## 10 GROUNDWATER

This chapter provides responses to submissions received on the draft environmental impact statement (EIS) related to groundwater of the Gas Field Component of the Queensland Curtis LNG (QCLNG) Project.

**Table 3.10.1 Responses to Submissions on the Draft EIS**

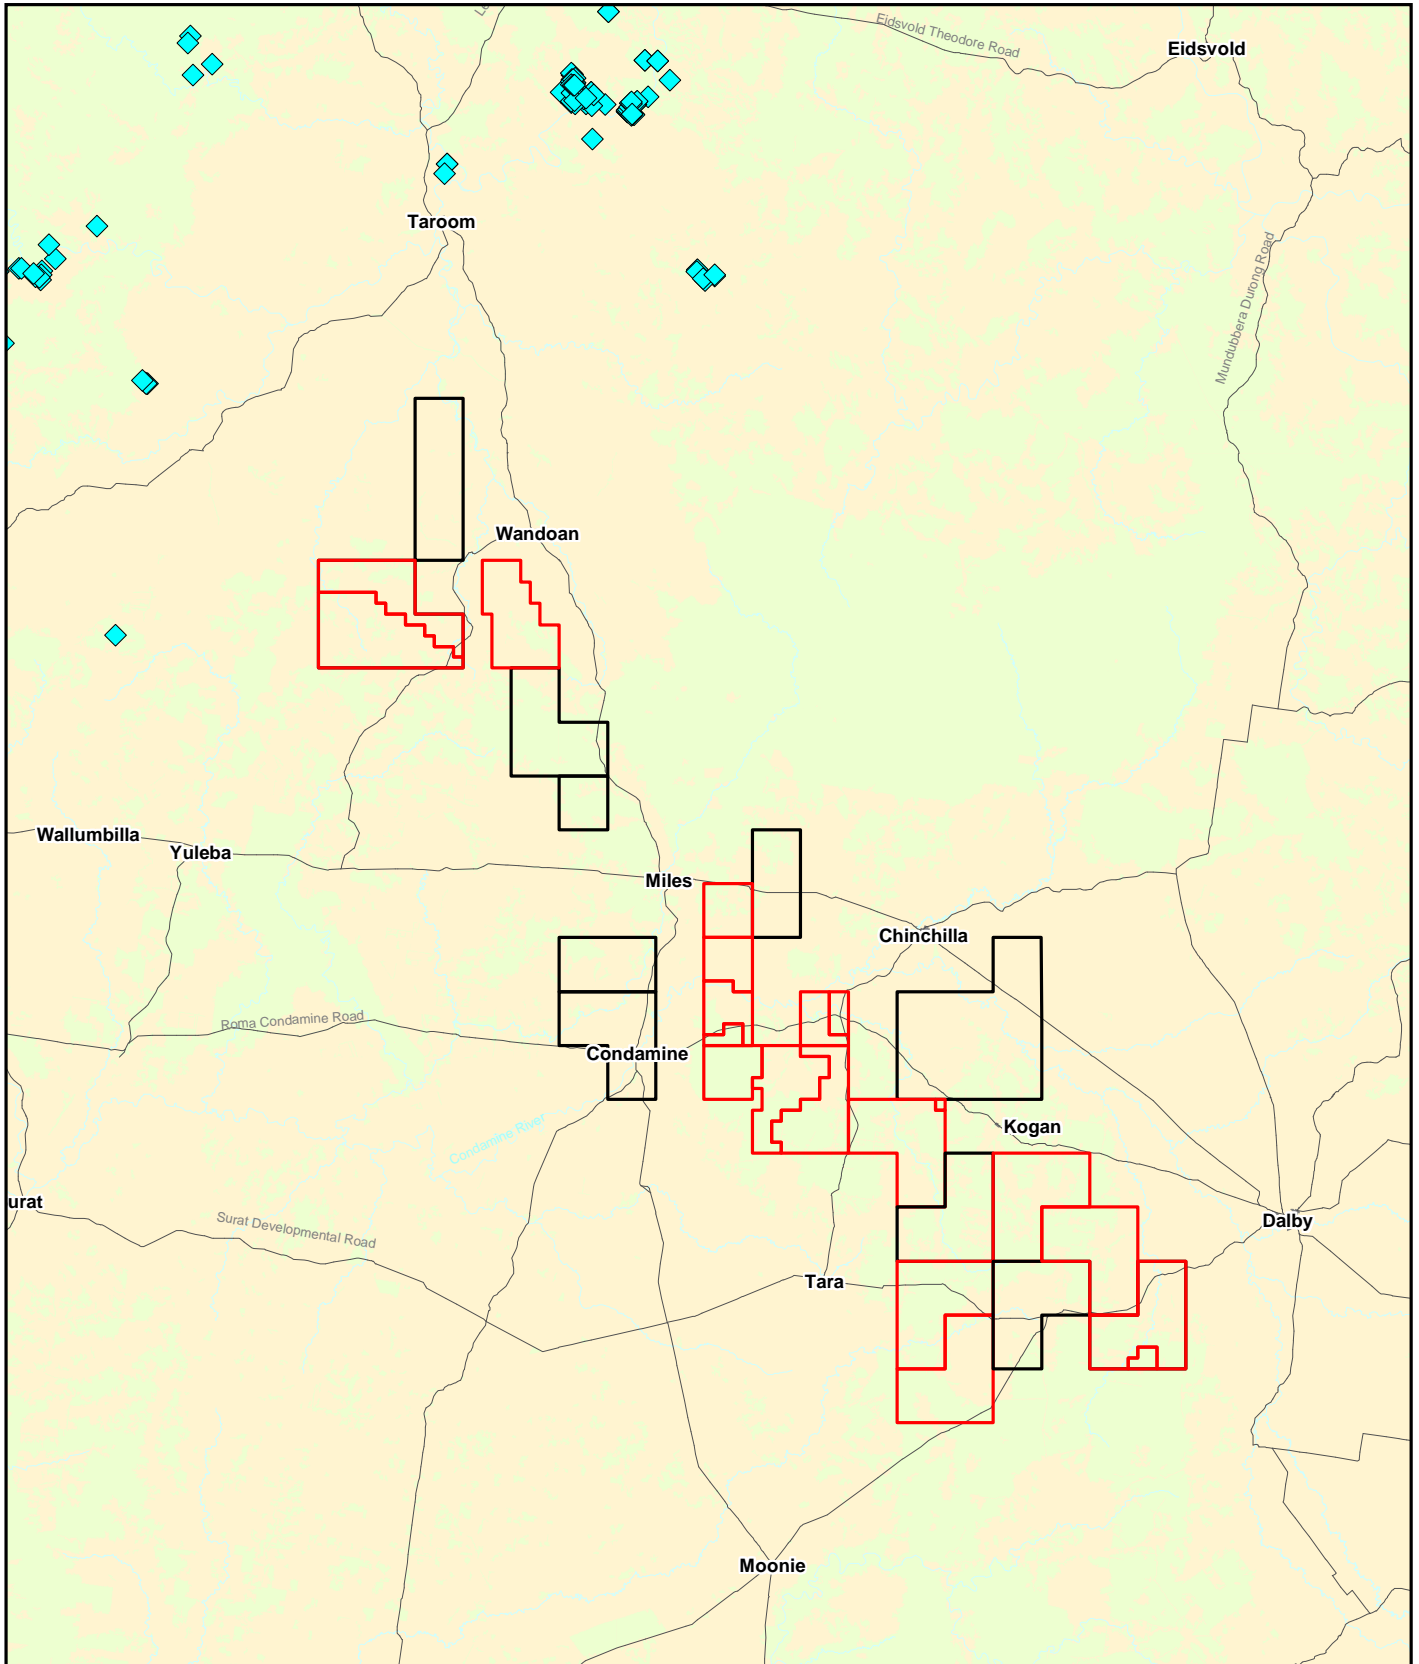
Present predicted groundwater drawdown cones graphically overlaid on the model domain so that extent and shape of drawdown can be readily assessed. Include estimated drawdown impacts from the proposed Santos’ Gladstone LNG project operations.	Refer to <i>Section 10.2.2.1</i>	32
The Great Artesian Basin Resource Operations Plan (GAB) establishes a register of springs which support significant environmental and cultural values in the GAB area. There are a number of springs on the register located in the Surat North and Surat Management Areas. The EIS should list and map these springs and consider the potential impact of Project activities on them.  Information should be provided that shows the source of groundwater in springs likely to be affected by the proposal.  As springs occur 40 km from the northern boundary of the study area (Appendix 3.4, 4.4.6), and the modelled drawdown is apparent up to 60 km from the bores ( <i>Figure D 11, Appendix 3.4</i> ), it is reasonable that the impact on these springs should be fully assessed.	Refer to <i>Section 10.2.1.3</i>	32

No springs were identified in the Project area although there are some springs within 30 to 50 km of the Project area. There are no known mound springs within the footprint of the CSG Fields, including the potential area of influence of CSG depressurisation activities (refer to *Figure 3.10.1*). At 30 to 50 km the predicted drawdown in the Springbok Sandstone aquifer (Injune Creek Group), Hutton and Precipice aquifers is anticipated to be negligible.

Recharge springs are typically situated within the recharge zones of the eastern margin of the GAB according to Habermehl and Lau (1997). Although a few recharge springs are identified 40 km from the northern boundary of the study area, based on modelling results, this distance is far enough that impacts are not likely to be noted. Nonetheless, as a precautionary measure,

monitoring of the main aquifers will occur between the CSG operational areas and the locations of these springs in accordance with QGC's groundwater monitoring plan. The purpose of this monitoring would be to enable additional mitigation measures to be implemented if monitoring of these bores detected any impacts in excess of the predicted scenario.
